STAFF RECOMMENDATION 2406 Barton Avenue July 19, 2017

Application: New construction – addition and outbuilding
District: Hillsboro-West End Neighborhood Conservation Zoning Overlay
Council District: 18
Map and Parcel Number: 10411017400
Applicant: Martin Wieck (nine12 design), Architect
Project Lead: Sean Alexander, sean.alexander@nashville.gov

Figure 1: Rear addition to be removed is noted with arrow.

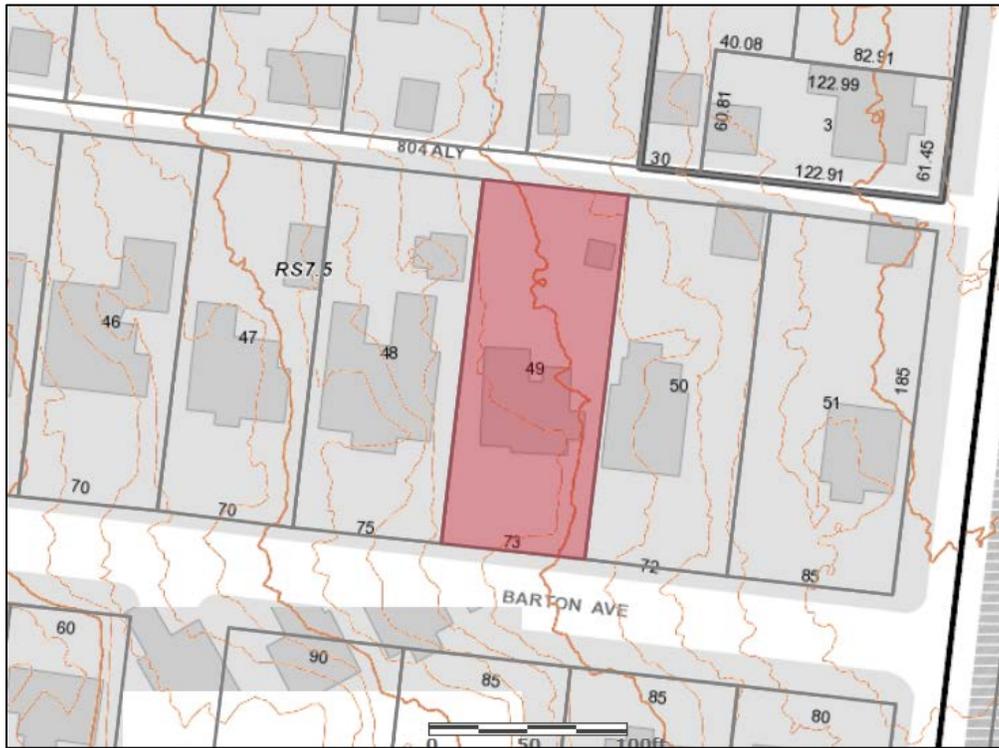
Demolition: The earlier rear addition will be demolished in its entirety. Because this portion of the house is not original, Staff finds that it does not contribute to the architectural and historical character and significance of the building, and that the partial demolition therefore meets Section III.B.2 for appropriate demolition and does not meet section III.B.1 for inappropriate demolition.
